CHANGE ORDER
CITY OF VALDEZ

DATE ISSUED: August 23, 2018
CHANGE ORDER NO. 14
COST CODE NO. 310-6450-58010
PROJECT NO. 310-6450
CONTRACT NO. 1283

PROJECT: Phase 2 New Harbor Development
Upland Facilities and Inner Harbor
Facilities

PROJECT	COV NHD Phase 2 Upland & Inner Harbor Facilities	ASI NO.	ASI-007A
CONTRACTOR	Pacific Pile and Marine, LP	CONTRACT NO.	1283
ORIGINATOR	MCG & RSA Engineering Inc.	PROJECT NO.	310-6450 (2)
DATE SUBMITTED	6/8/2018

WAREHOUSE - FLOOR PLAN
SHEET
88 of 100
A3

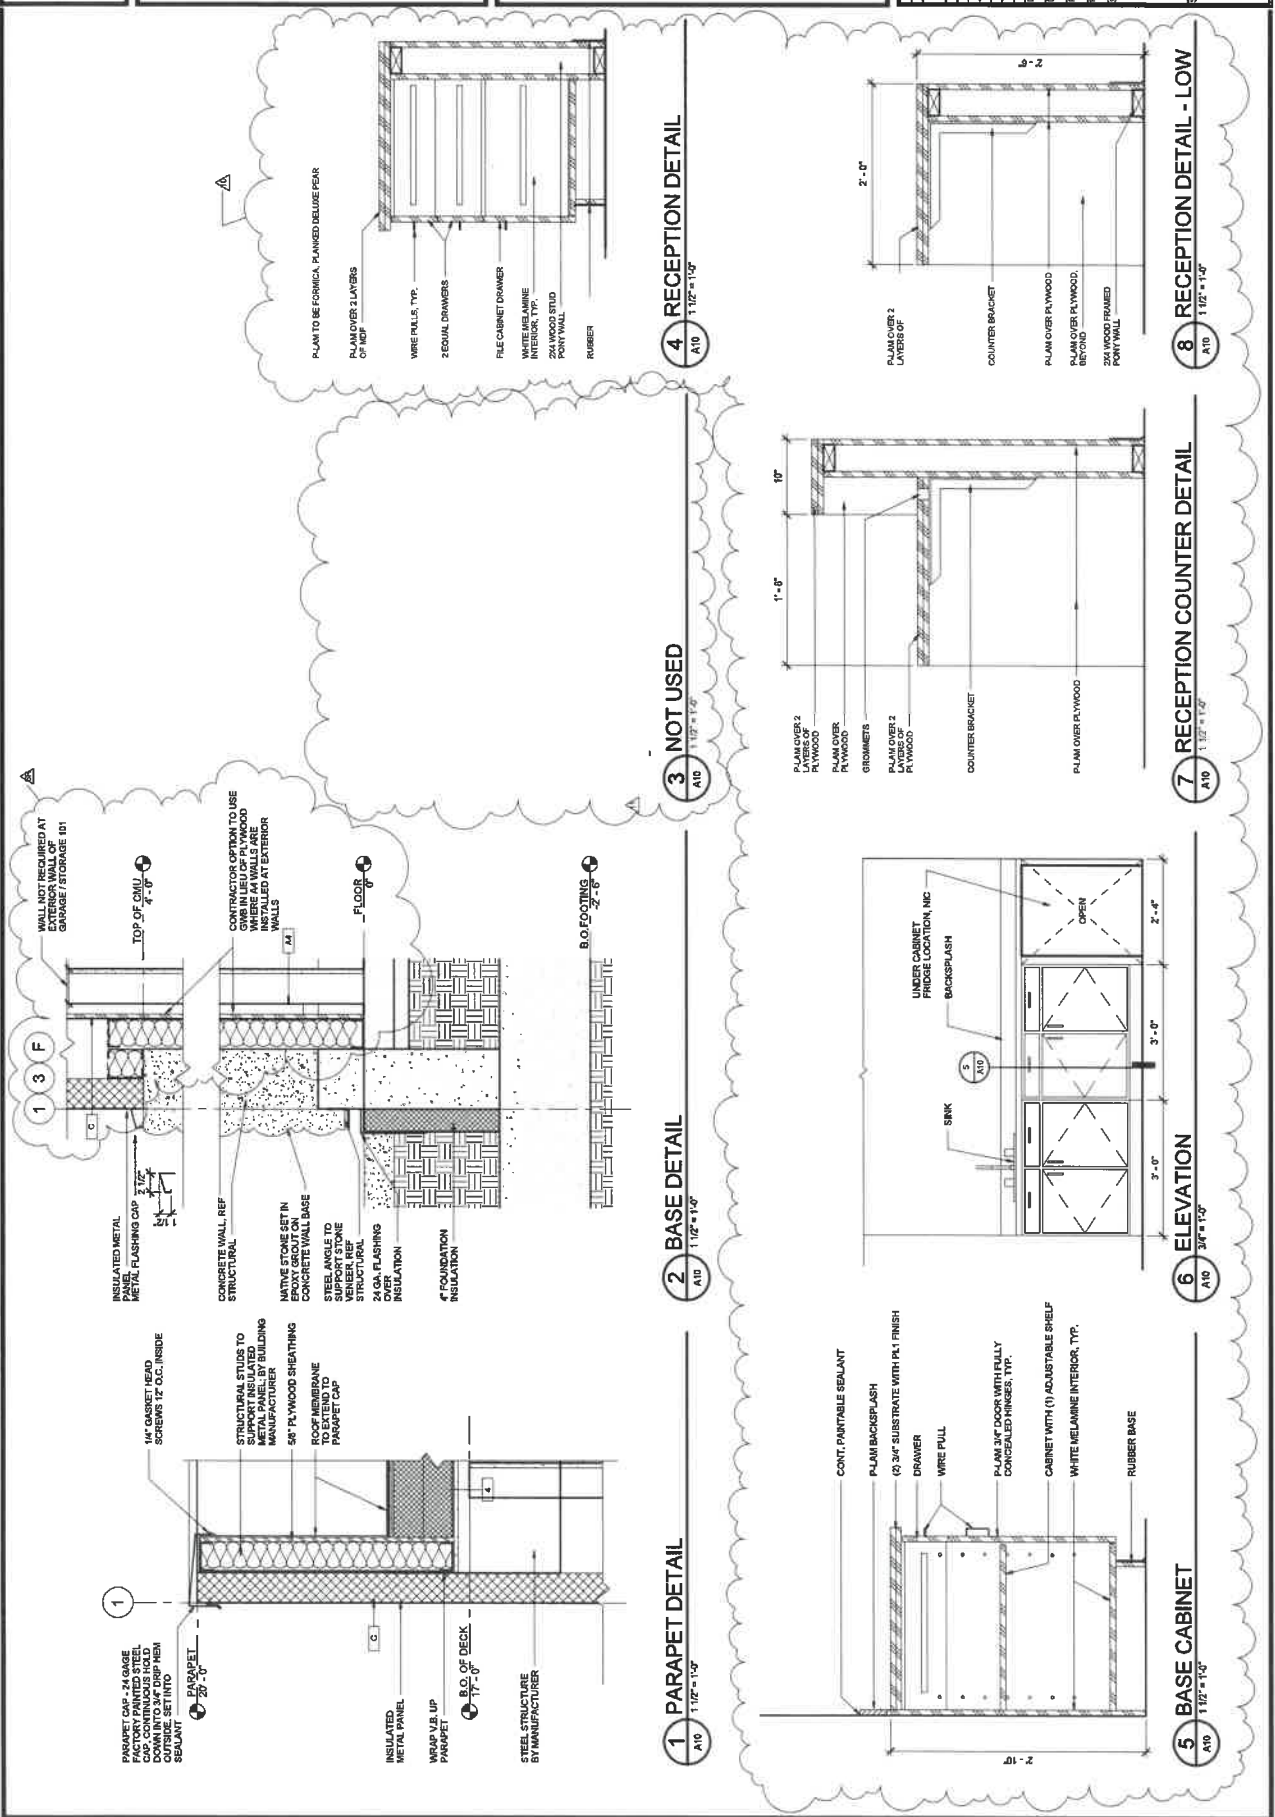
- Drawing A3; Updated plan layout for reference. Updated sheet notes.
 - Drawing A10; Delete table detail; scope to be provided by others.
 - Delete specified washer boxes and replace with direct piping connections. Connect washers to two-inch waste stub outs as shown in attached sketches and manufacturer's instructions.

2 SHOWER DETAIL
NO SCALE

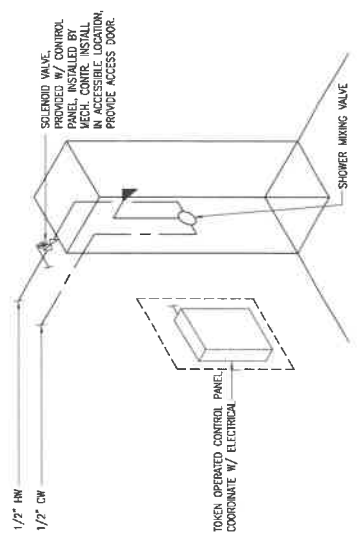
- Do not add concrete housekeeping pad for washers noted in ASI-007. This will be replaced by an 8" tall metal frame base to be provided by others.
- 2) Shower 109: Revise for installation of coin token operated showers. Install owner-furnished HM5 token acceptor and associated solenoid valve to each shower hot water supply.

1 WASHING MACHINE DETAIL
NO SCALE

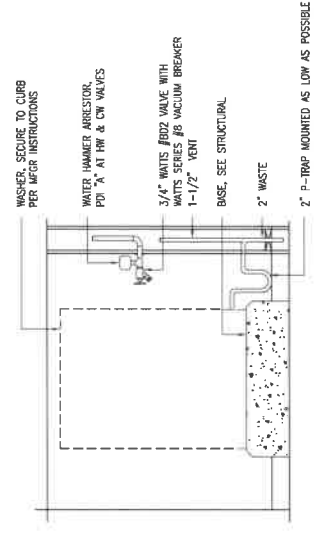
- Increase water pipe sizing to washer connections per manufacturer's instructions.
 - Revise exhaust air duct sizing as shown.
 - Change makeup air duct size and configuration as shown per manufacturer's instructions.

SKE-2

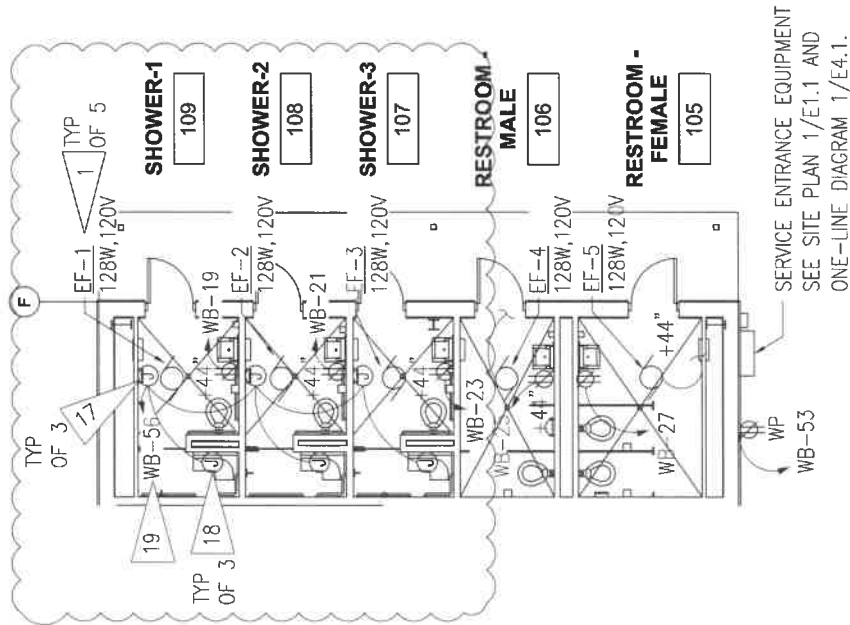
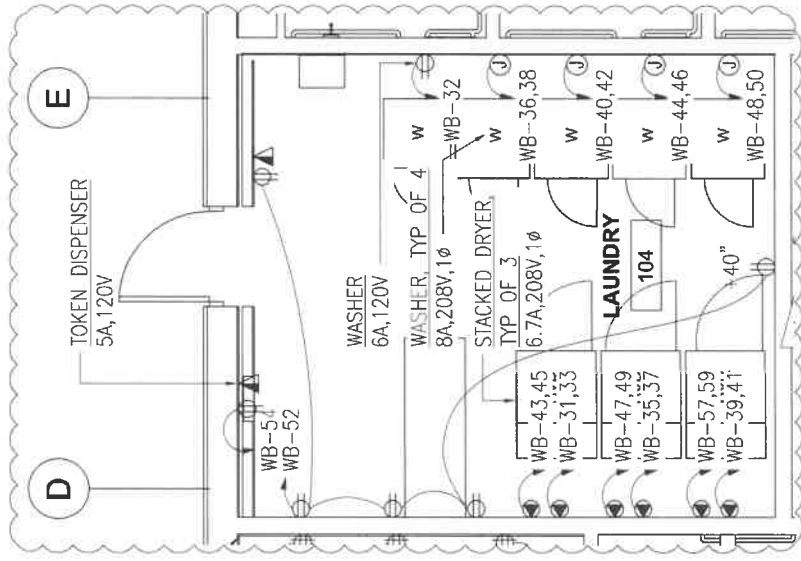
- Add motorized damper to make up air. Damper motor to be 120V power open, spring close. Damper motor will be wired by laundry contractor.
 - Remove 15A/2P breaker for plan north washer circuit and reused for 6th circuit for stacked dryers.

- Revise circuiting for dyers as shown in SKE-3.
 - Provide 15A/1P breaker for smaller washer unit. Provide 120V receptacle.
 - Repurpose roughed in conduit/junction boxes for now removed 2 most northern dyers for general purpose receptacles. Extend washer room circuit WB-52 to these locations.
